THE ESSELTINE DRAIN: ADDENDUM REPORT—BOOK 3

SECOND ONSITE MEETING 25 JANUARY 2017
LANDOWNER QUESTIONS AND COMMENTS

RC SPENCER ASSOCIATES INC.
Consulting Engineers

Project No.: 14-425

Figure 6: Tracy Reimer – Property Drainage Route

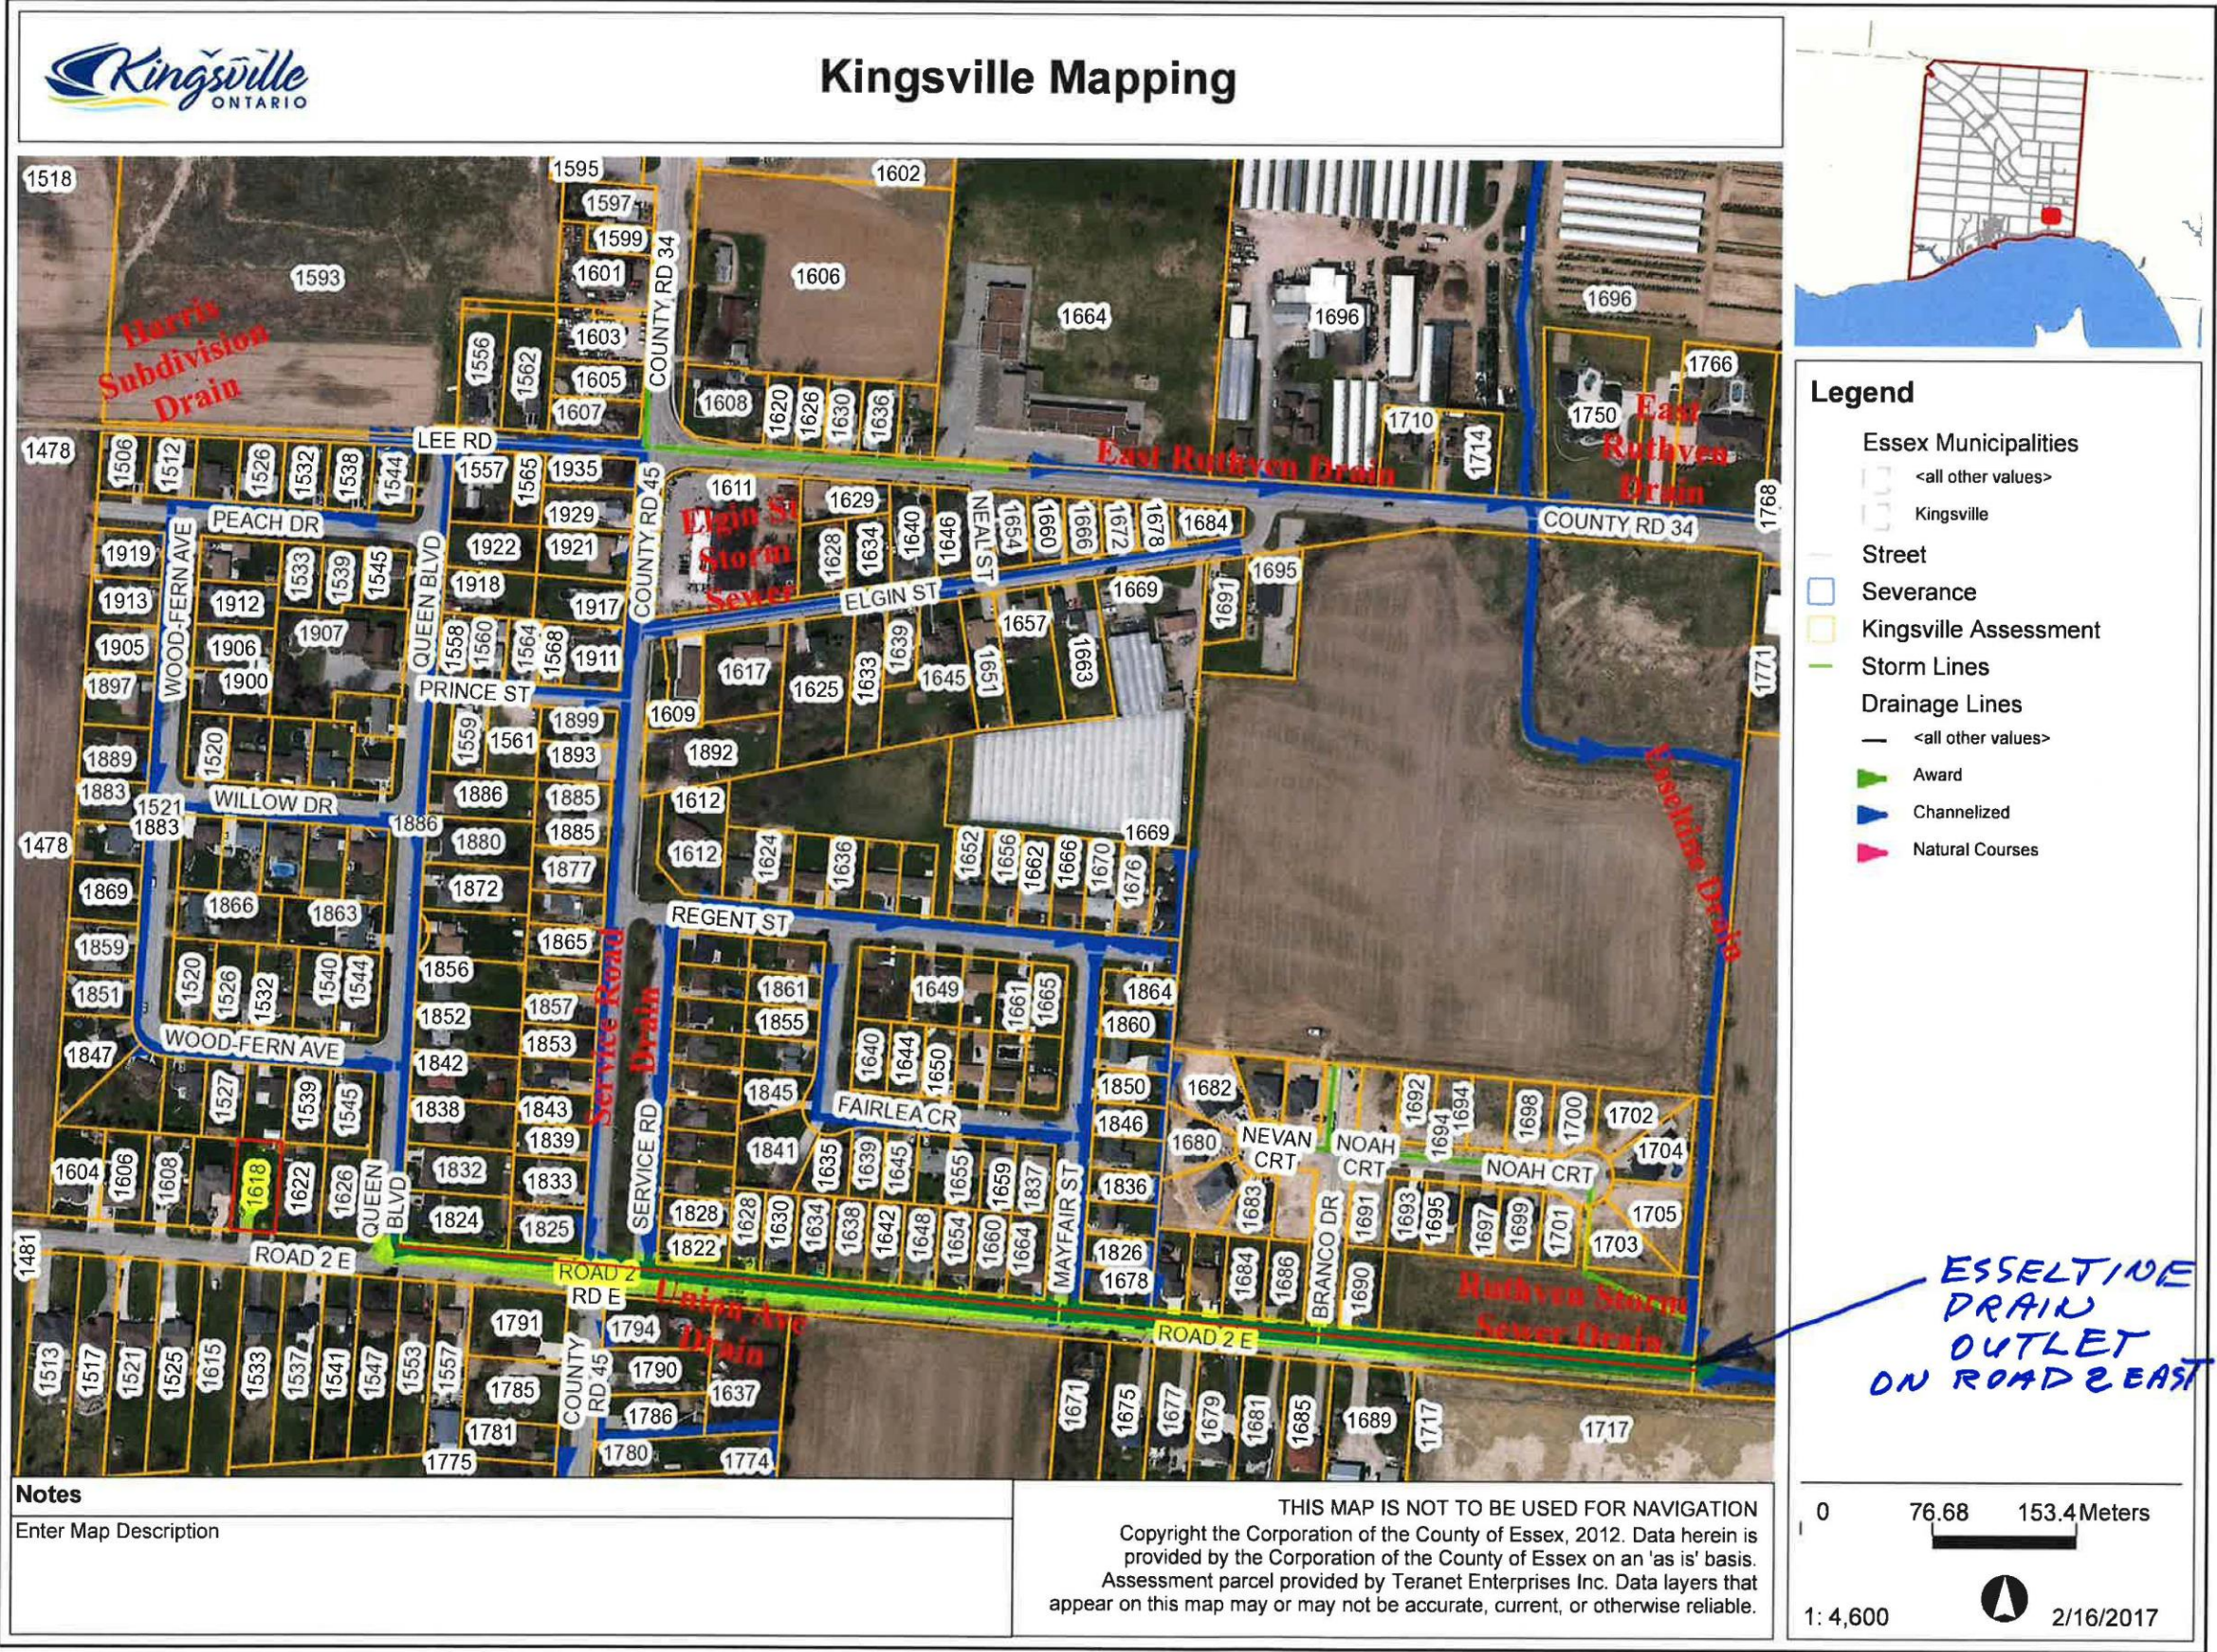
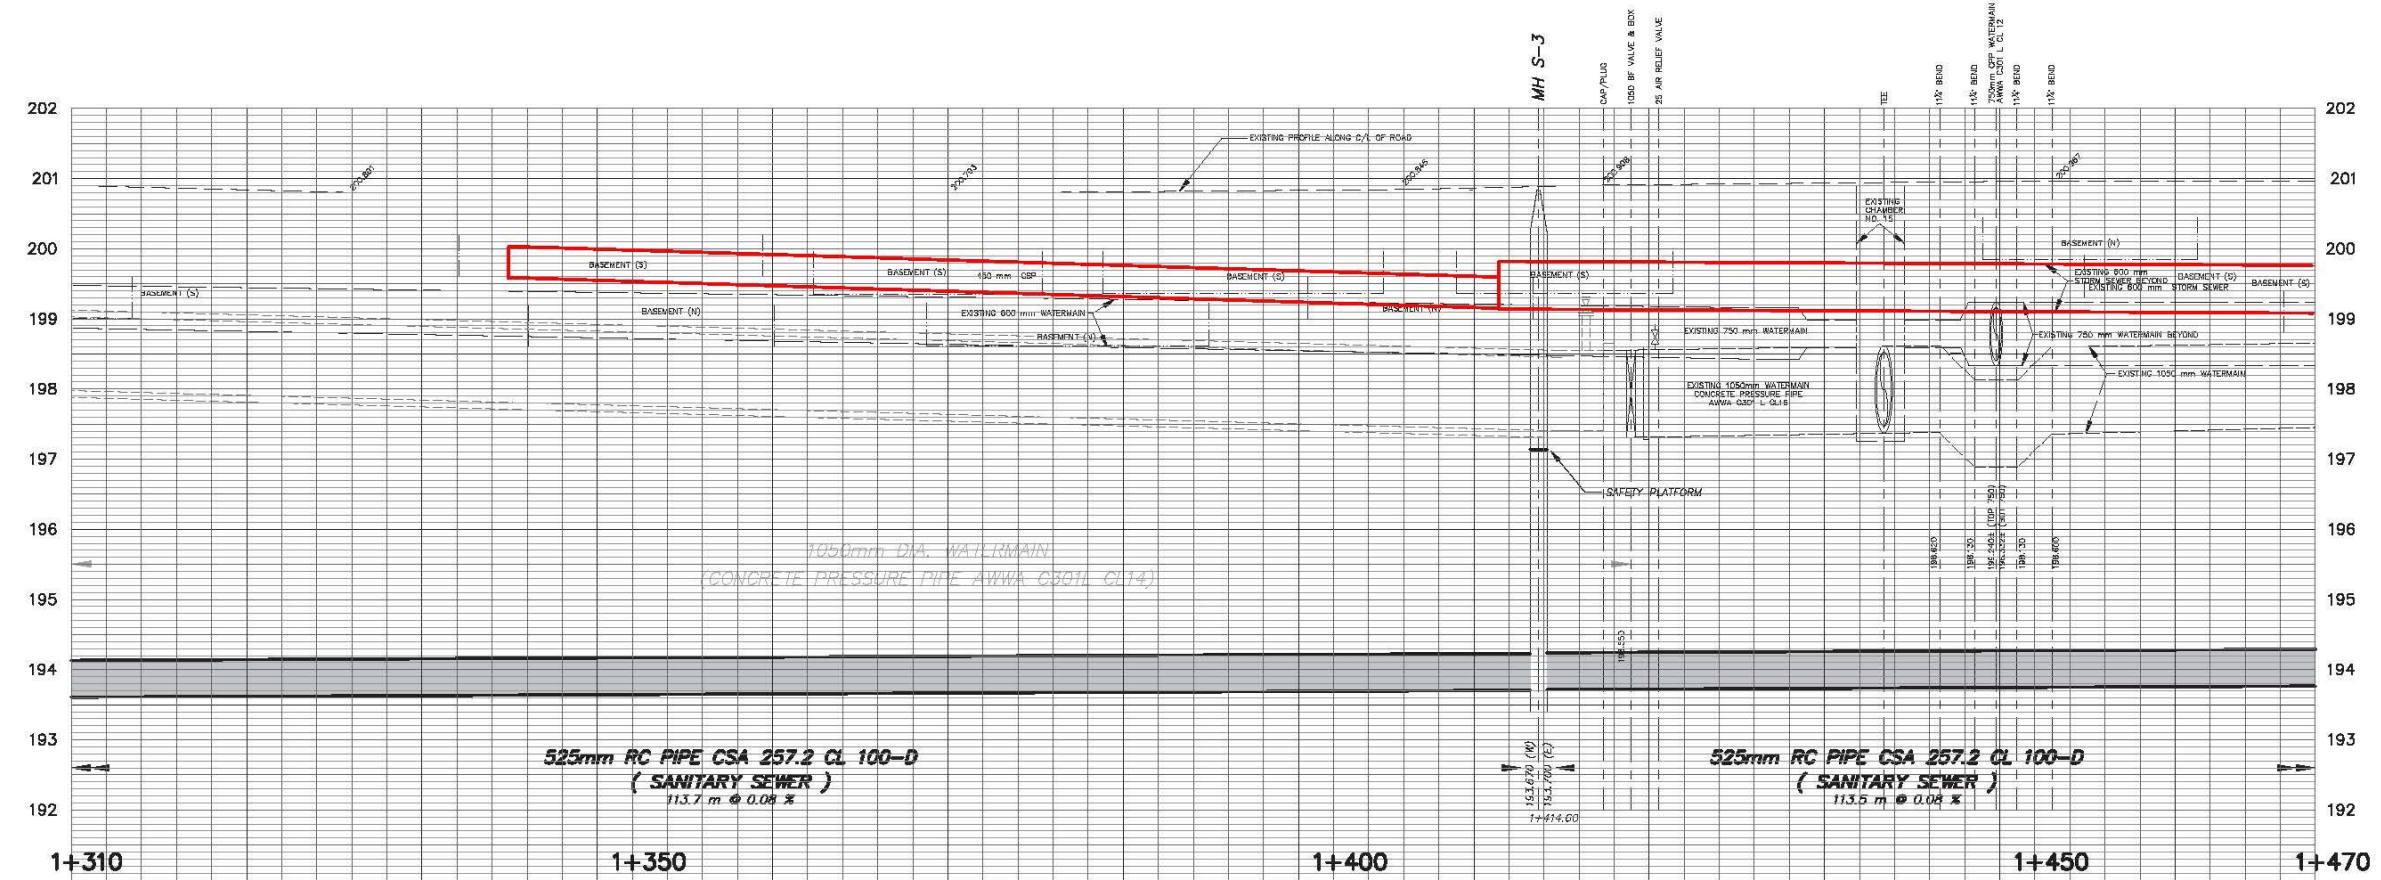
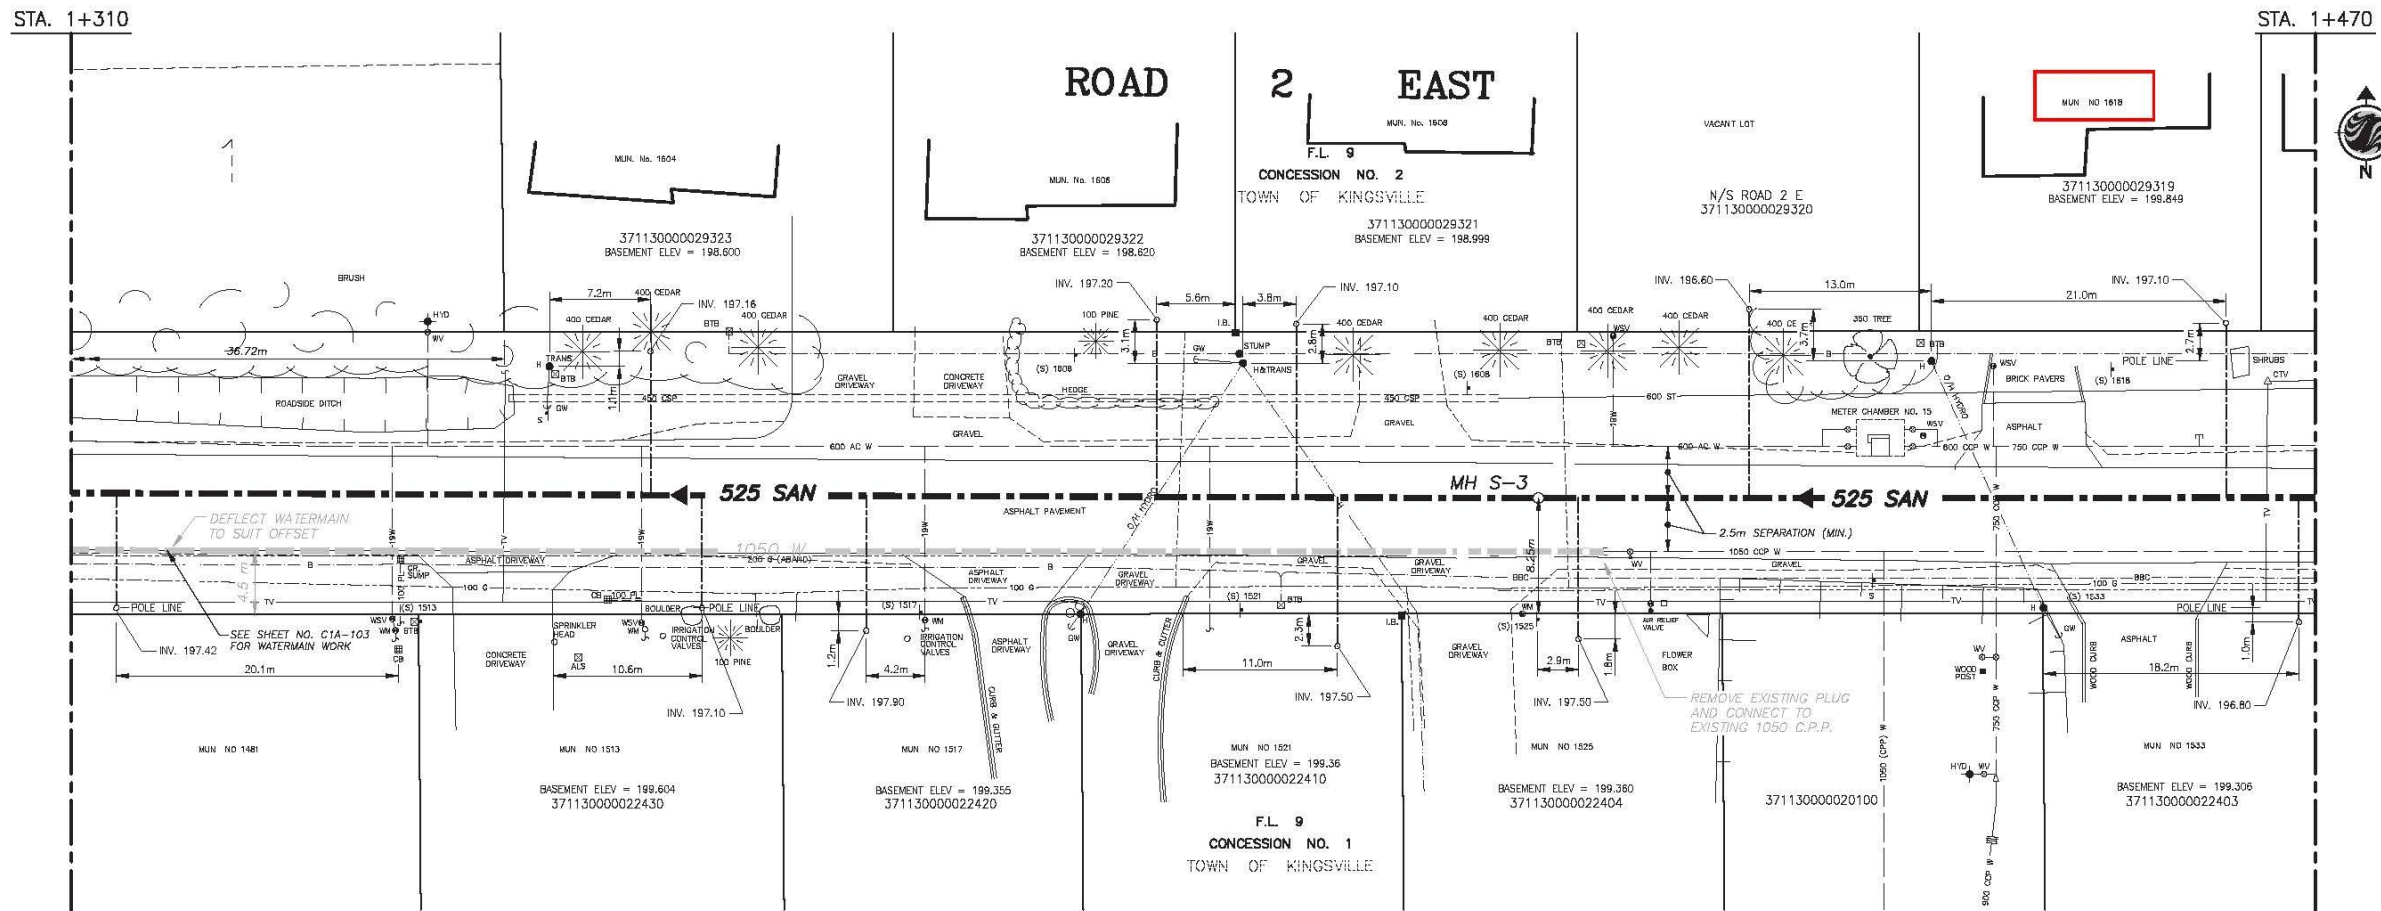
10)	Tracy Reimer 1618 Road 2 E Roll No.: 300-29316	January 25, 2017	1) Can I get a drainage map showing how my property reaches the Esseltine Drain?	1) We have attached two documents to this email. The first one being a profile of the storm sewer that is fronting your property. The storm sewer is highlighted in red along with your property. As you can see the storm sewer fronting your property is flowing East (towards Queen Blvd.) and connects to Union Avenue Drain at Queen Blvd. The second document shows how Union Avenue Drain connects to the Esseltine Drain. Your property and the path the water takes to get to the Esseltine Drain are highlighted in yellow. - Please see page 15 and 16 (Figure 6 & 7) for attachments
